APPEAL SUMMARY

Appeal ID: 33560	Project Address: 1117 SW Harvey Milk St
Hearing Date: 11/6/24	Appellant Name: Skylar Leavitt
Case No.: B-010	Appellant Phone: (458) 278-7559
Appeal Type: Building	Plans Examiner/Inspector: Guy Altman
Project Type: commercial	Stories: 4 Occupancy: R-2 Construction Type: IIIB
Building/Business Name: Fairfield Apartments	Fire Sprinklers: Yes - NFPA 13 System
Appeal Involves: Alteration of an existing structure	LUR or Permit Application No.: 24 091688-CO
Plan Submitted Option: pdf [File 1] [File 2]	Proposed use: Multi-family, 51+ Units

FAIRFIELD APARTMENTS

Sheet Title:
PLANS & DETAILS -
ALCOVE GATES

3 FLOOR PLAN: LEVEL 1 - EAST ALCOVE GATES
G-002 (3/8" = 1'-0")

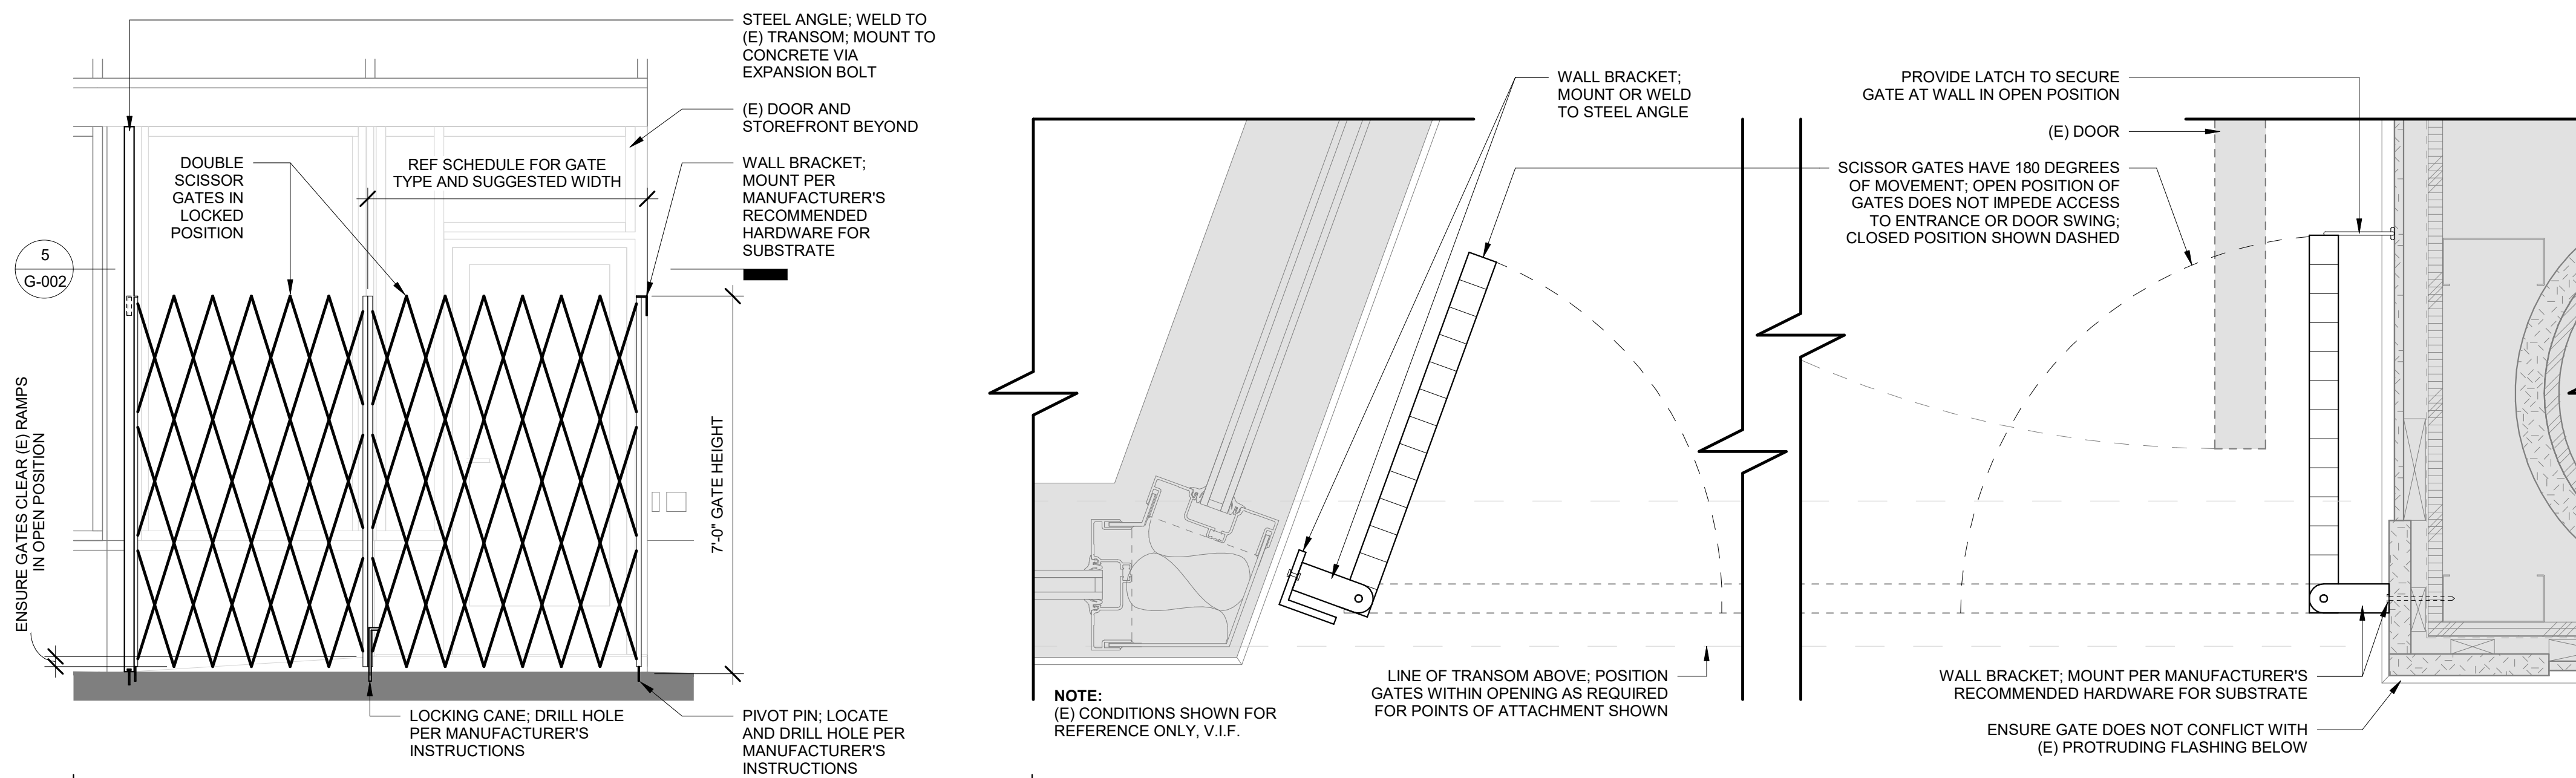
Code Section	2022 Oregon Structural Specialty Code Section 1010.1.7 Door Arrangement
Requires	Space between two doors in a series shall be 48 inches minimum plus the width of a door swinging into space. Doors in a series shall swing either in the same direction or away from the space between doors.
Code Modification or Alternate Requested	An exception to the distance required between doors in a series to allow for the installation of a security gate as proposed.

An out-swinging security gate is proposed at the east exit passageway alcove along SW 11th Ave. The existing depth of the alcove does not allow for the space required between two doors. The gate will be located as close to the property line as existing conditions allow in order to achieve the maximum distance between the existing door and the new gate. The gate will remain closed, but will have panic hardware and allow for egress at all times for the egress side. Both the egress door and gate will be able to be opened by actuator button that will open both in unison from inside or the exterior. This automatic opener will be hooked up to battery power so it will operate in case of loss of power. The gate will have metal mesh applied on the inside of the gate to allow for visibility as occupants exit the building while preventing exterior reach through.

Refer to the attachment drawings for proposed gate design.

The existing conditions at the east exit alcove is constrained by the existing egress door and the front facade of the building. The proposed gate will have no other impact on the existing conditions. The proposed panic hardware and actuator opener will ensure that the doors remain safe for occupants and remain accessible.

APPEAL DECISION**Omission of 48" space between exterior door and security gate: Granted provided security gate encroachment into ROW is approved by PBOT.**

6 ELEVATION: SWING GATE
G-002 (1/2" = 1'-0")

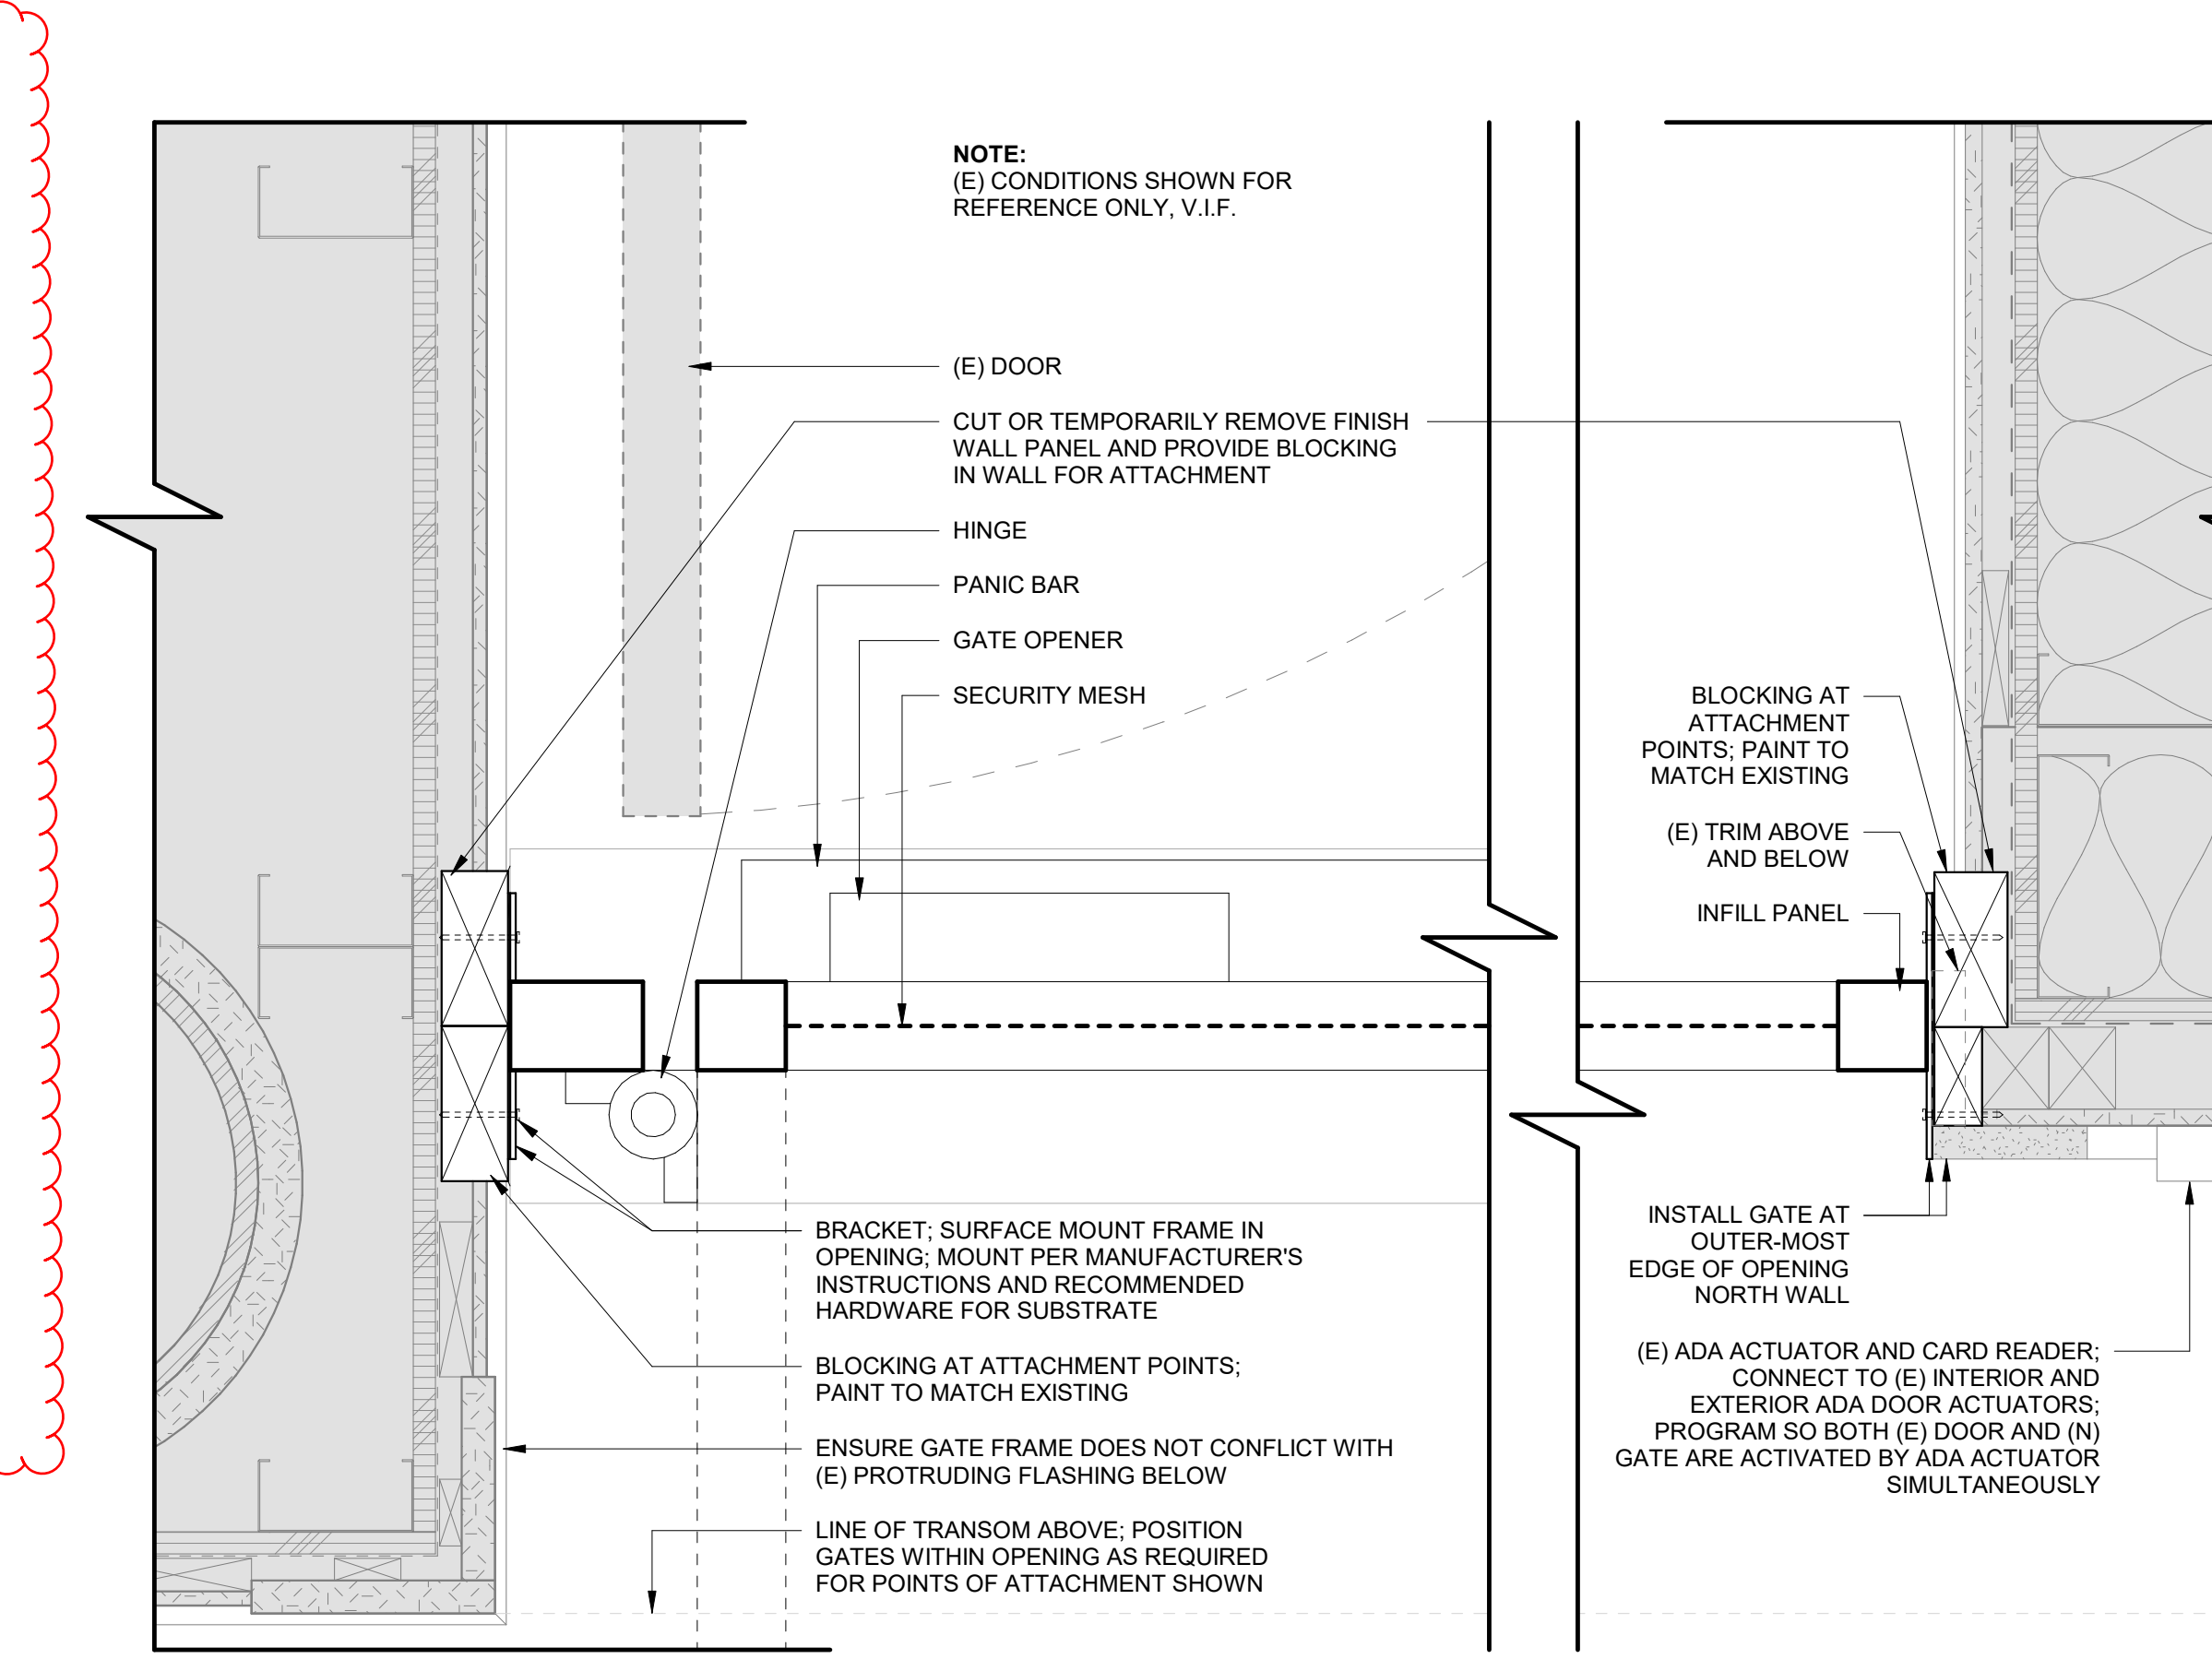
*ENSURE SWING GATE IS IN COMPLIANCE WITH THE 2017 OREGON ACCESSIBILITY CODE SECTION 404.3.4, EXCEPTION 1 OR 2.
